## Service Bulletin

### Generator firmware ATP Console updated and fixation of the skid plate guard improved

- This document announces the release of Generator firmware ATP Console V7R1b94.
- The fixation of the skid plate guard has been improved in production (no field upgrade).

Figure 1: Previous design (left) and new design (right)

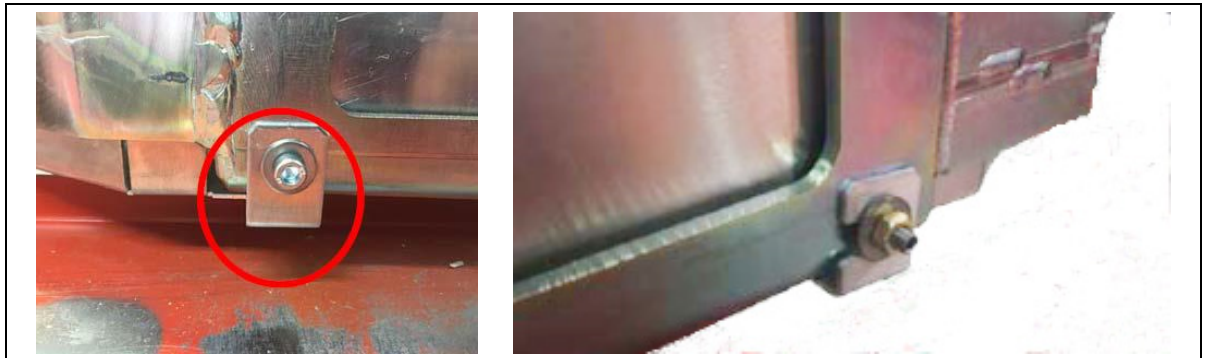
*Symptom* A damaged battery tray and metal fragments inside the unit have been found. This poses a safety risk, because a short circuit might be caused by the metal fragments inside the unit.

*Cause* For mobile systems with fix and telescopic column the skid plate guard is fixed to the frame by screws. If one of the screws has to be replaced because it is lost or damaged, the Field Service Engineer has to use the right screw length.  
If it is too short, the skid plate guard can't be fixed properly. If it is too long, the battery tray will be damaged.

*Solution* The current fixation of the skid plate guard to the frame will be changed from screw to nut ex-factory (no field upgrades are foreseen).  
A threaded rod with specific Loctite glue and a nut with washers will be used. The skid plate guard will also be modified by changing the hole drilled to open slots.  
For systems in the field the Field Service Engineer has to pay attention that a new screw has exactly the right length (M6x10) in case of replacement.
